QUALITY ASSURANCE -- NON-CONFORMANCE REPORT

Location: Changxing Island, Shanghai, P.R. China**Report No:** NCR-000974**Prime Contractor:** American Bridge/Fluor Enterprises, a JV**Date:** 21-Jan-2011**Submitting Contractor:** Zhenhua Port Machinery Company, Ltd (ZPMC), Changxing Island**NCR #:** ZPMC-0933**Type of problem:**

Reference Description: The weld repair was performed without following the approved repair WPS and WRR

Subject: NCR No. ZPMC-0933

焊缝返修位置示意图:

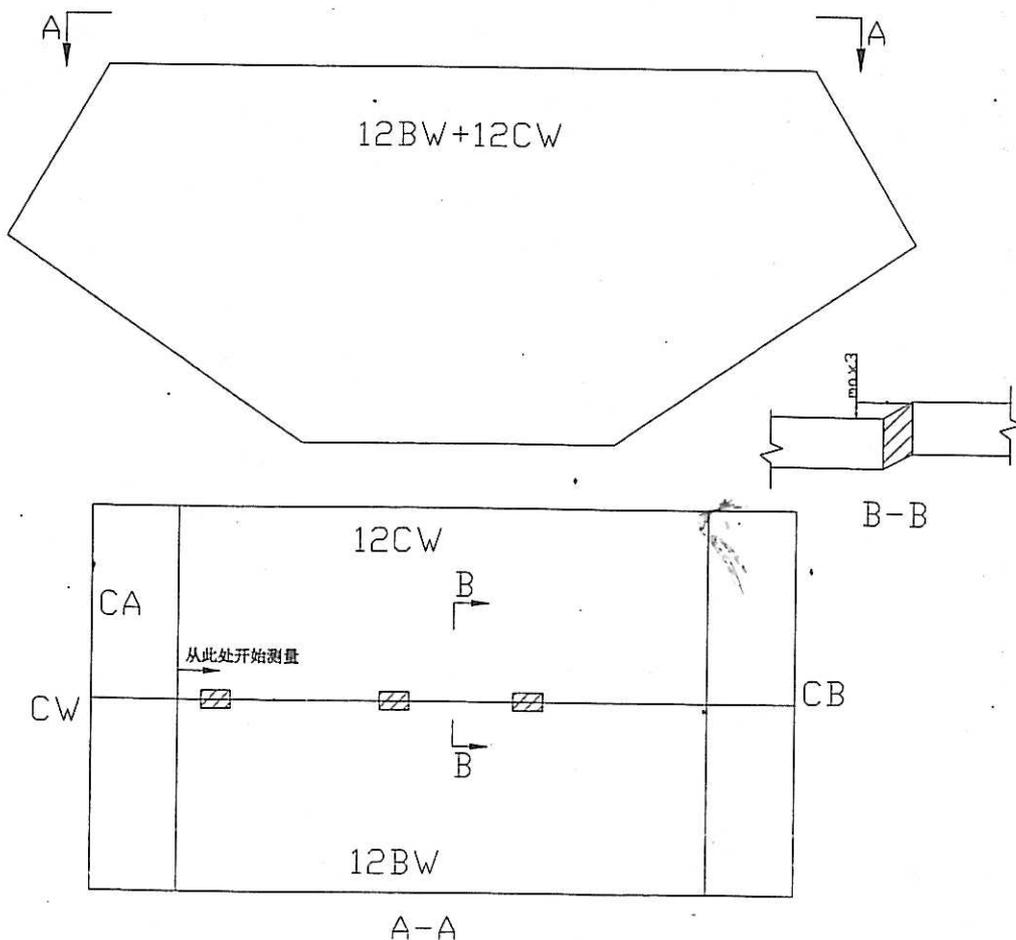
After inspection 12BW and 12CW deck plate butt weld, it was maximum 3mm misalignment at weld OBW12A-001, the position is 1070~1670、6570~7070、13150~13620 from the weld, and needs to cut to adjust.

Weld distortion and fabricate error.

1. Remove the welds by the way of gouging or Oxygen Preheat according to the WPS prior to gouging.
2. Perform 100%VT and 100%MT inspection to the metal cutting area to ensure no defects exist.
3. Adjust the misalignment and the straightness to meet the tolerance by extra force and ensure the stiff ener to meet the tolerance, and then perform tack weld.
4. Preheat and weld according to the approved repair WPS with check the line degree sometime.
5. Grind the weld flush to the adjacent weld or base metal.
6. Perform NDT inspection of the weld according to the working drawings.
